Preliminary Flood Assessment: President Private Hospital, Kirrawee, NSW

P1907286JR02V03
February 2022

7 Response to Agency Comments

Map Title / Figure:
Tuflow Model Setup
Boundary Conditions - (Viewport 3)

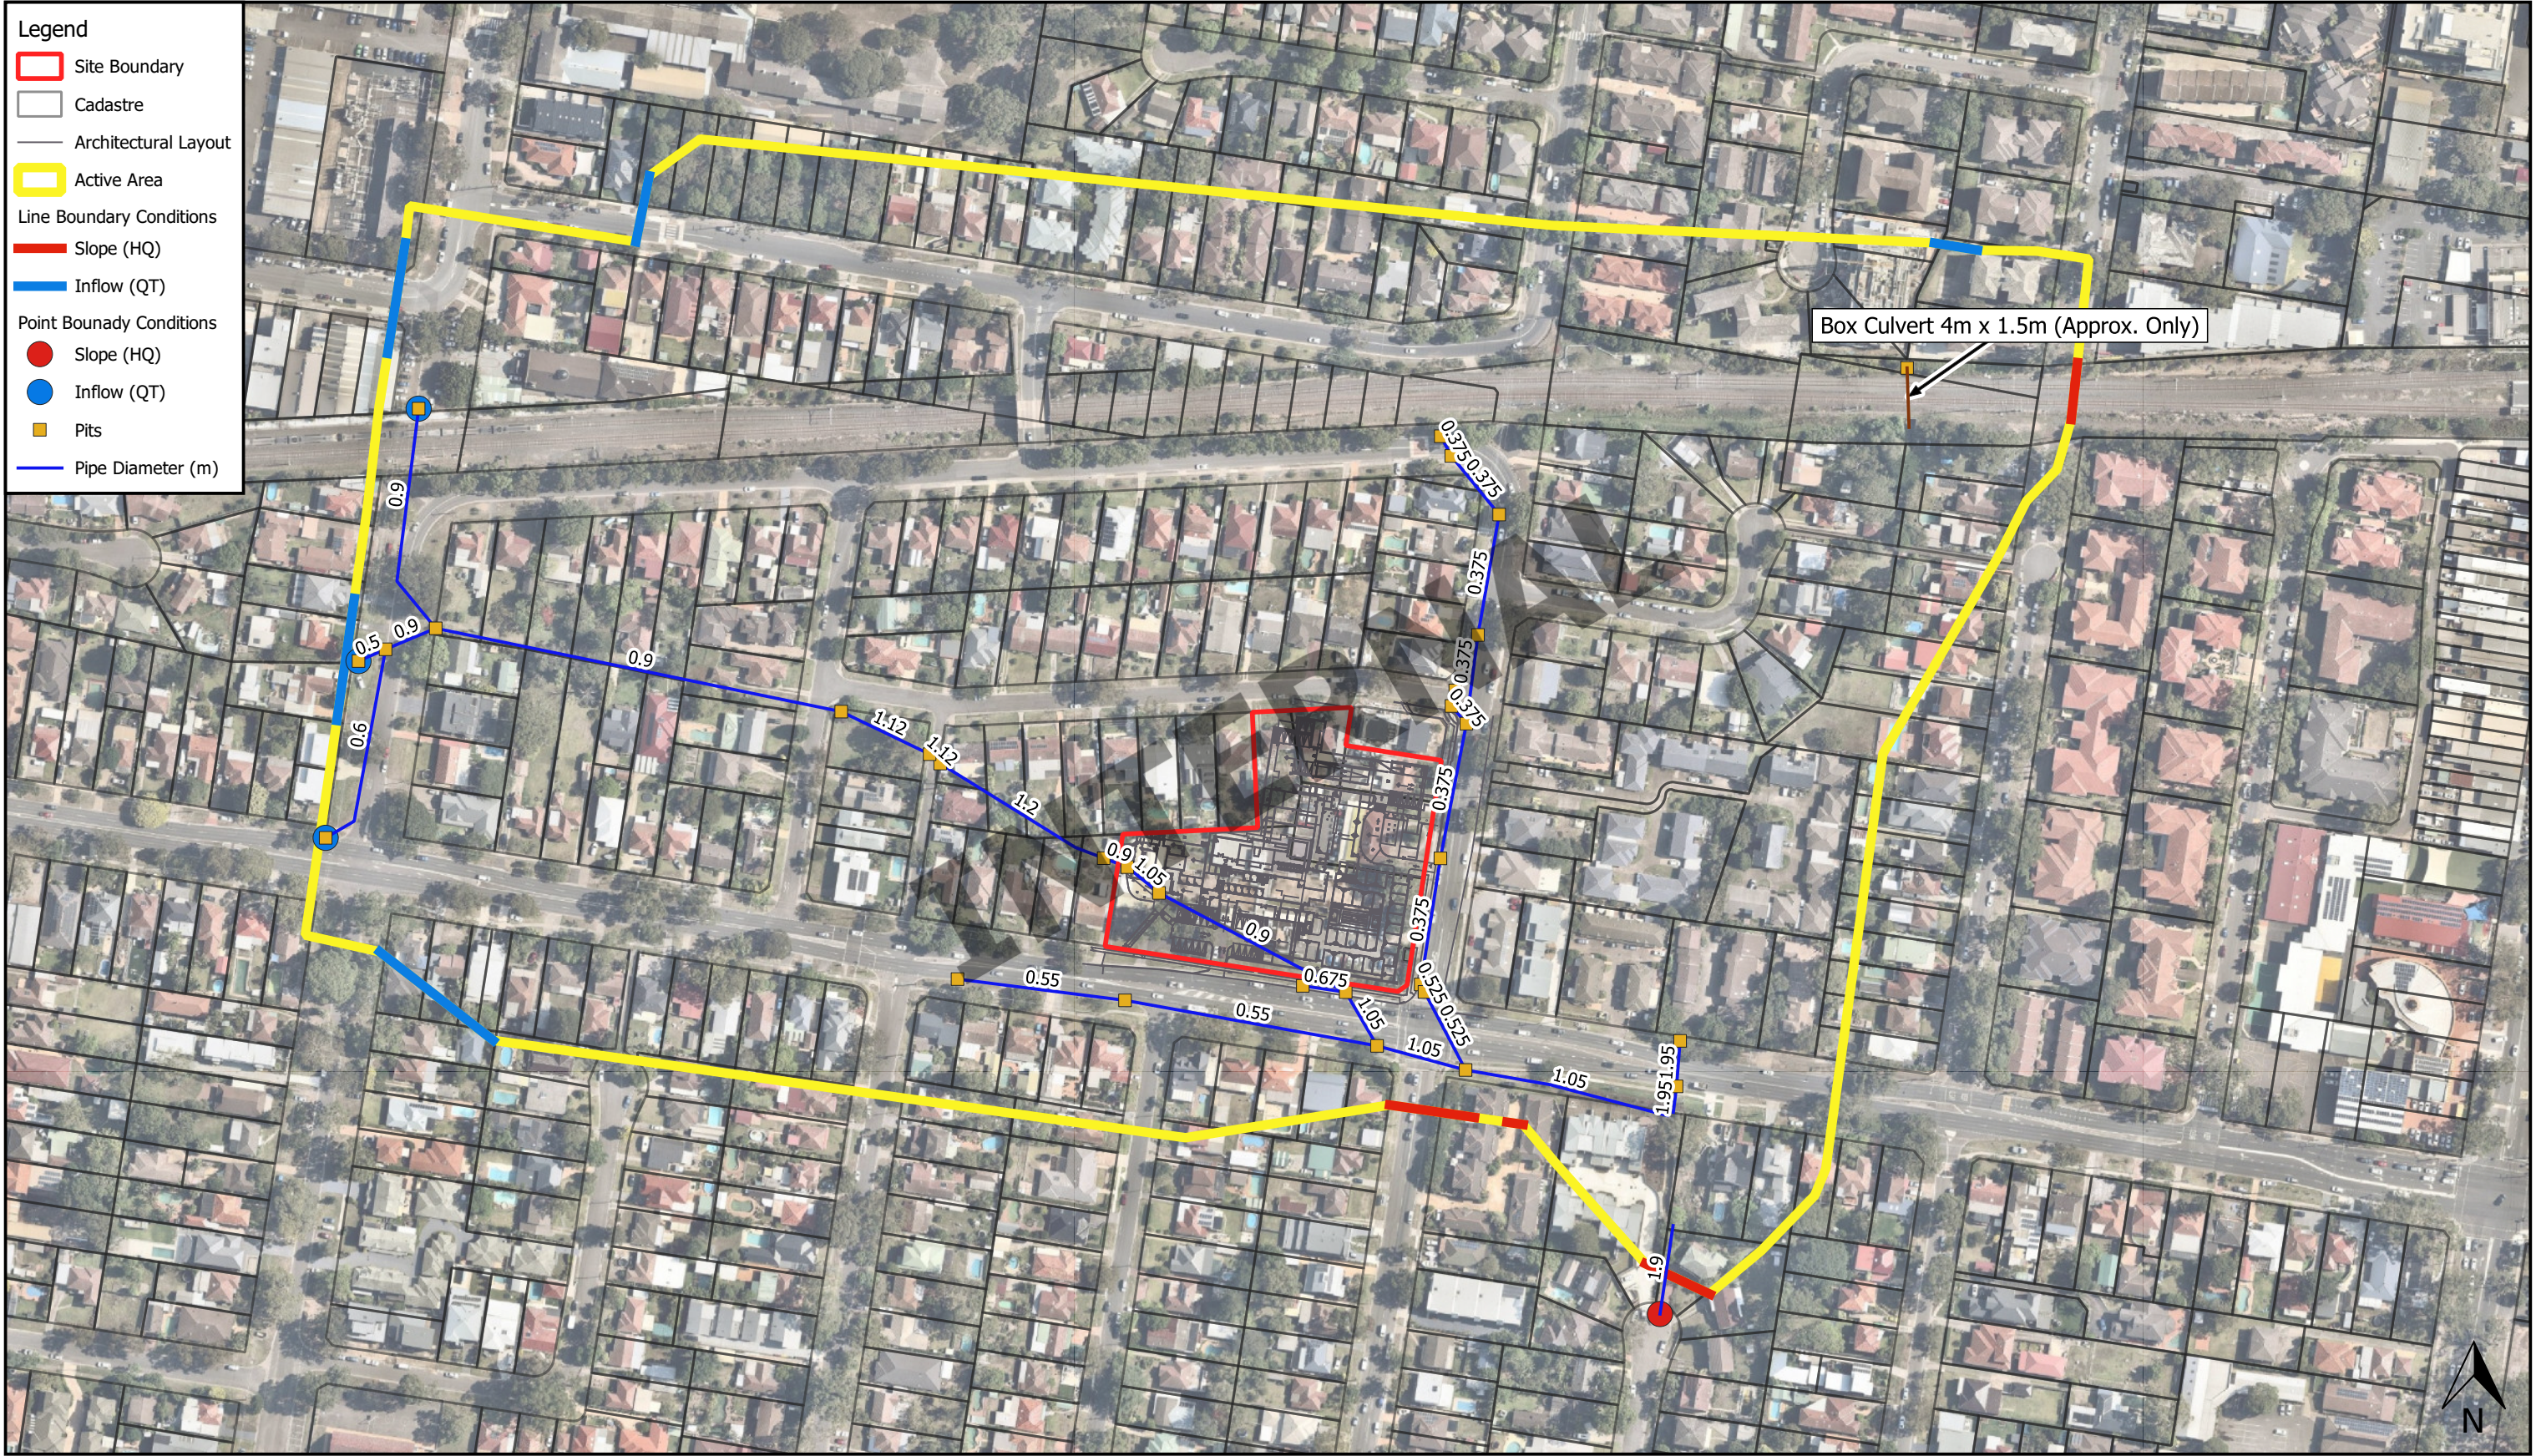
GRC Comments	MA Response
1. The stormwater survey is to be reviewed and verified to ensure that 'detailed survey of existing drainage infrastructure on the site' has been obtained as required by the project SEARs;	Survey discrepancies and details have been clarified by Australian Location Services surveyor (Attachment A). Additional survey on the downstream pits has been undertaken and the 1D pits and pipe network has been updated accordingly (Attachment C – Map 03)

GRC Comments	MA Response
4. The TUFLOW hydraulic model extent and boundaries should be extended away from the site (both upstream and downstream) to minimise boundary effects on model results. Alternatively, existing boundary conditions should be justified and documented through sensitivity analysis to ensure boundary assumptions do not influence stormwater and flood hydraulics at the site;	The TUFLOW hydraulic model extents and boundaries have been extended further away from the site both upstream and downstream. (refer to Attachment C – Map 03 for the updated model extent)
